# SITE PLAN

PROJECT TYPE:  
GARAGE ADDITION

ADDRESS:  
5195 TOPAZ  
COLORADO SPRINGS, COLORADO

### **GARAGE ADDITION - UNHEATED**

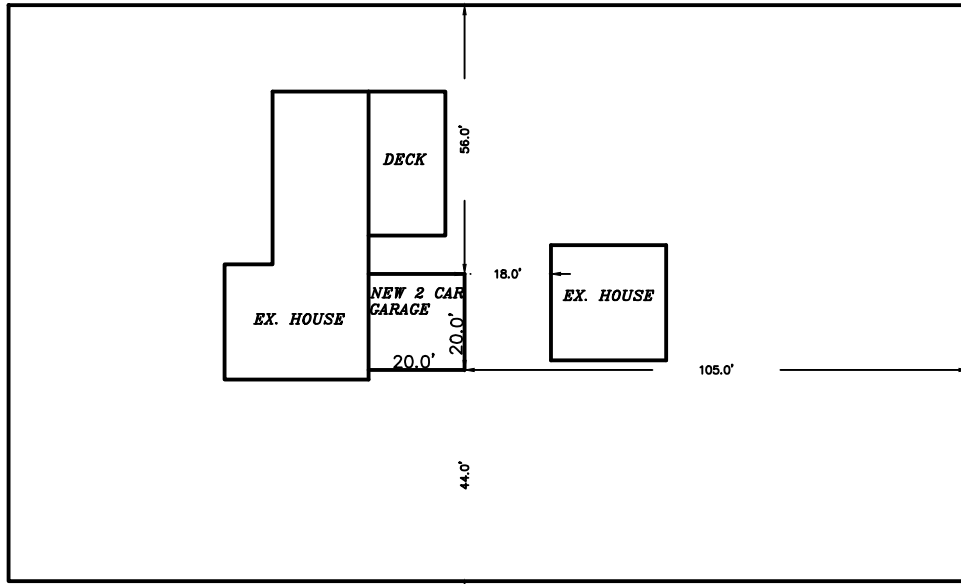
It is the owner's responsibility to coordinate with easement holders to avoid impact to utilities that may be located in the easements.

**Alterations, repairs and additions: When interior alterations, repairs or additions requiring a permit occur in existing dwellings, the dwelling unit shall be provided with smoke alarms AND carbon monoxide alarms located as required for new dwellings; smoke alarms shall be interconnected and hardwired.**

**GARAGE / DWELLING SEPARATION:**  
1/2" gypsum board applied to the garage side and protecting supporting construction. 5/8" Type X gypsum applied to the garage ceiling when habitable space above. Door(s) to garage from dwelling must be solid core or 20 minute rated.
